World Forum for Harmonization of Vehicle Regulations

189th session

Proposal for Supplement 8 to the 03 series of amendments to UN Regulation No. 51

Submitted by the Working Party on Noise and Tyres*

"Figure 4a

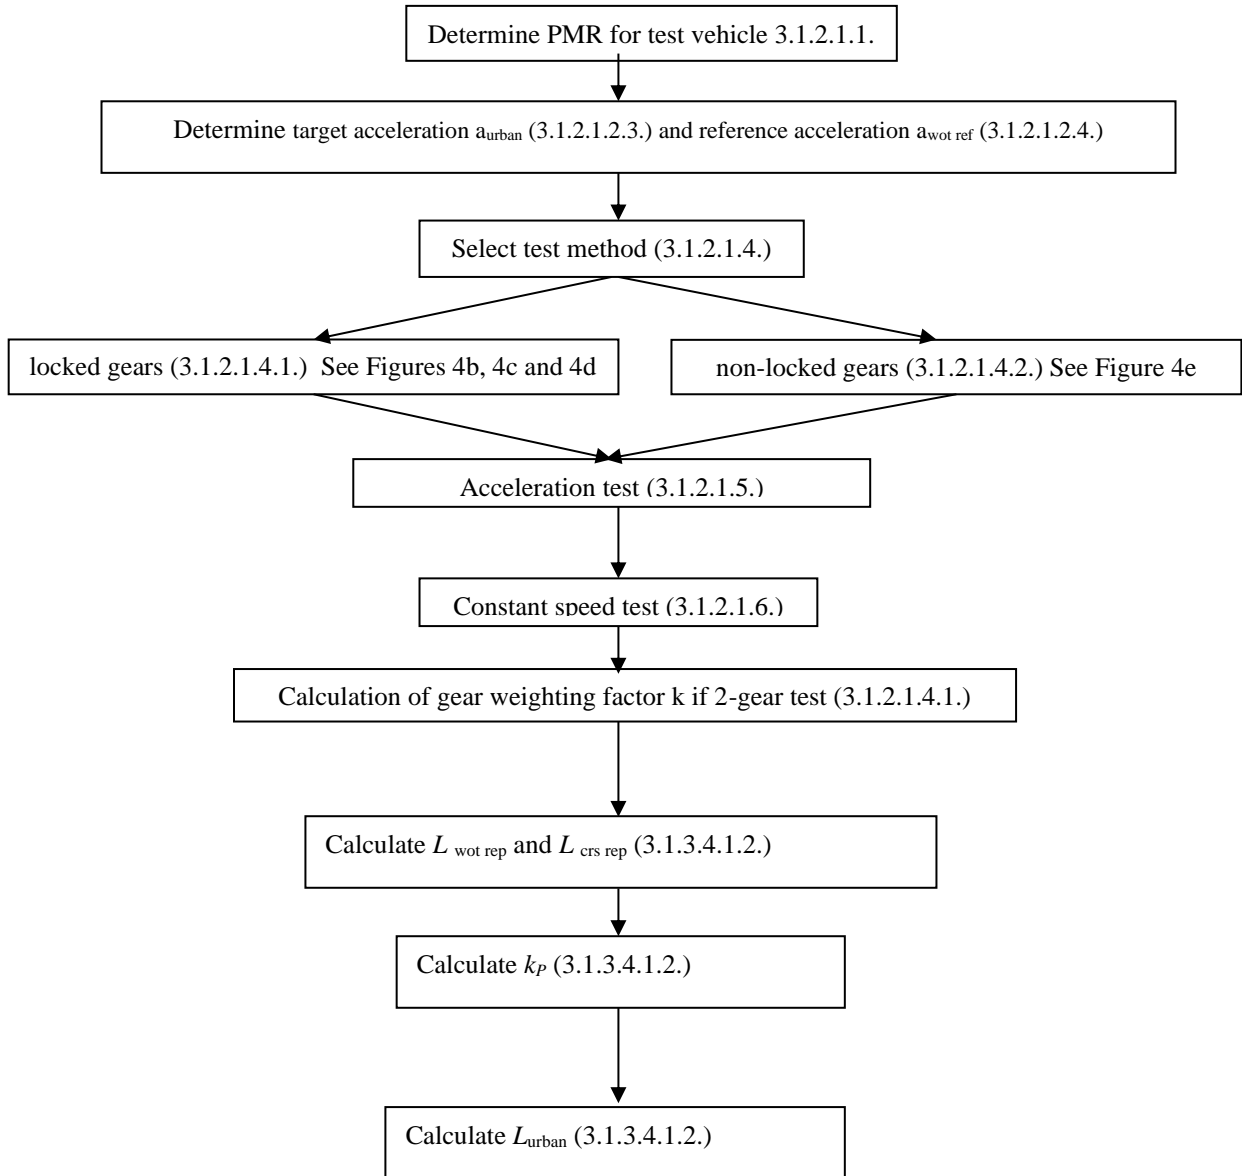
Figure 4a, amend to read:

Flowchart for vehicles tested according to paragraph 3.1.2.1. of Annex 3 to this Regulation – L_{urban} computation

"Figure 4b

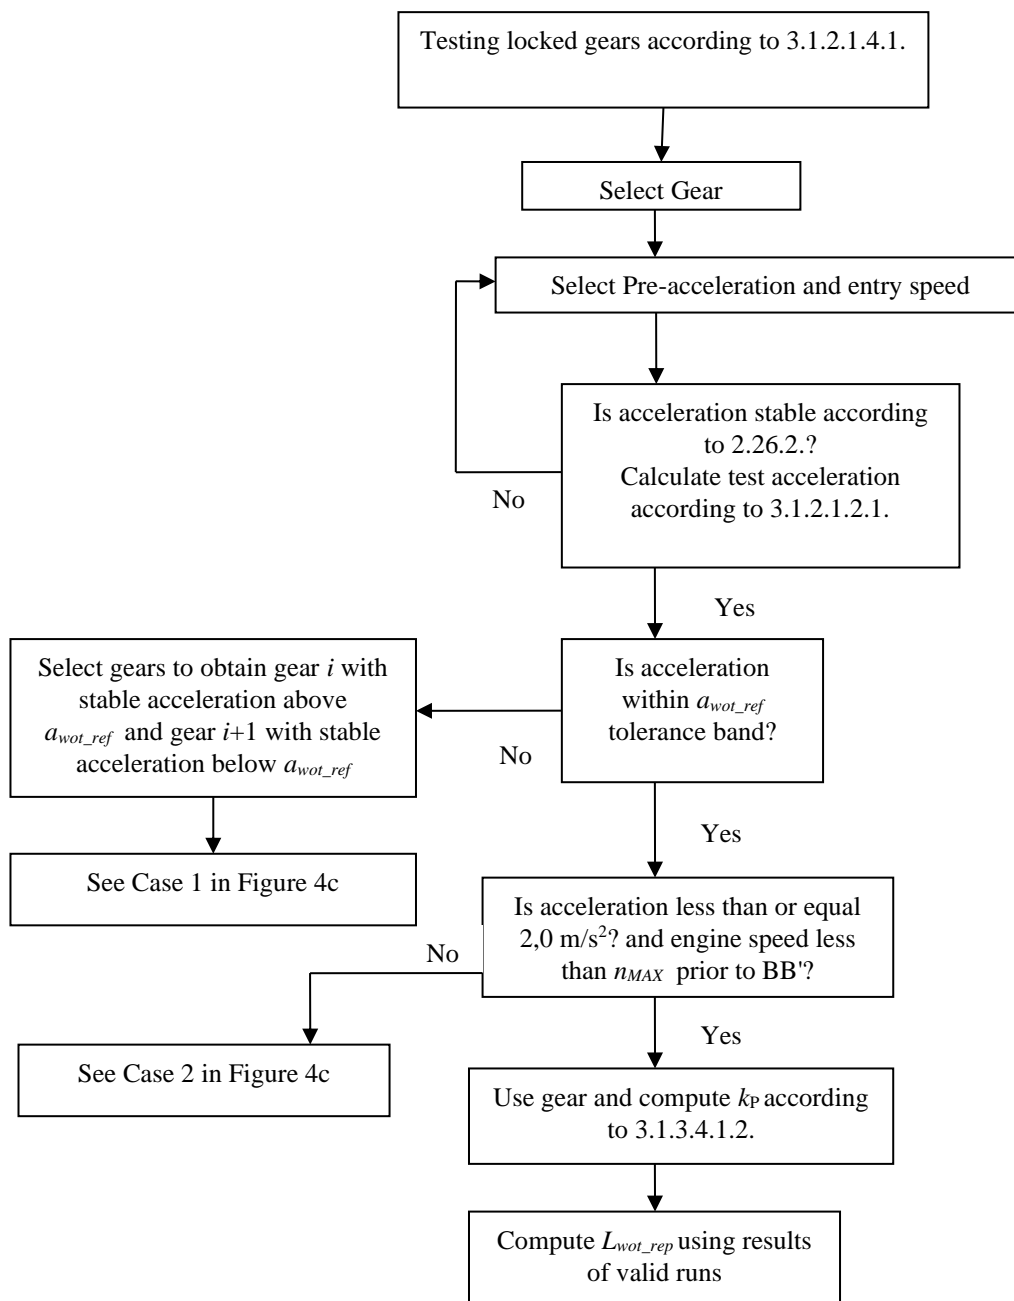
Figure 4b, amend to read:

Flowchart for vehicles tested according to paragraph 3.1.2.1. of Annex 3 to this Regulation - Gear selection using locked gear PART 1

"Figure 4c
**Flowchart for vehicles tested according to paragraph 3.1.2.1. of Annex 3 to this Regulation –
 Gear selection using locked gear PART 2**

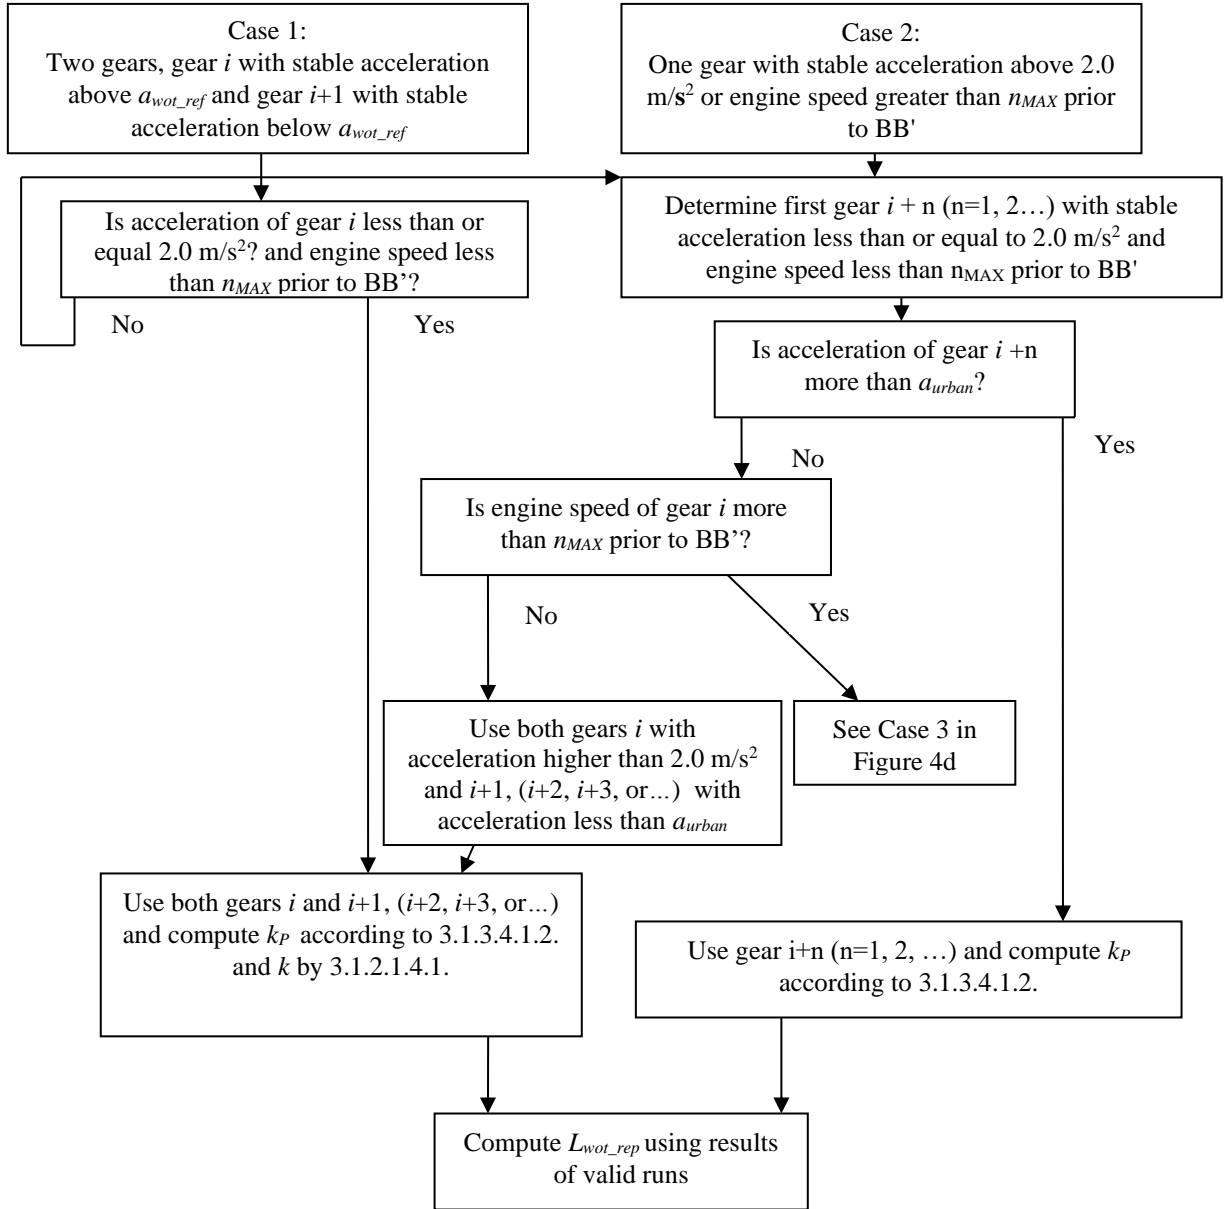
Figure 4c, amend to read:

"Figure 4d

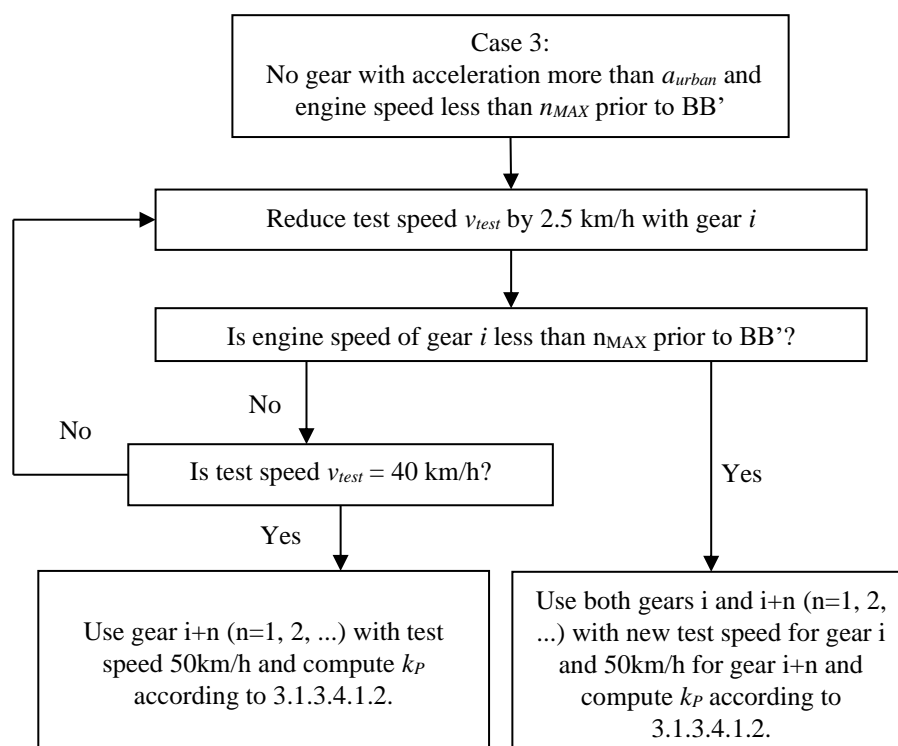
Figure 4d, amend to read:

Flowchart for vehicles tested according to paragraph 3.1.2.1. of Annex 3 to this Regulation – Gear selection using locked gear PART 3

"Figure 4f

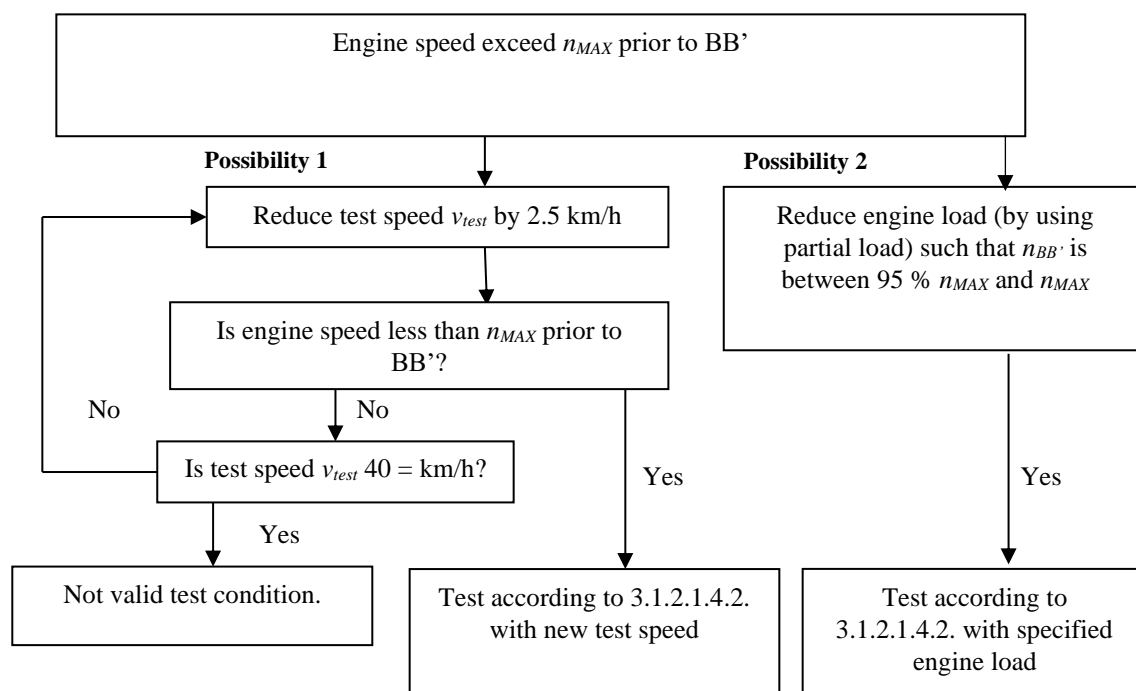
Figure 4f, amend to read:

Flowchart for vehicles tested according to paragraph 3.1.2.1.4.2. of Annex 3 to this Regulation – Gear Selection using non-locked gears
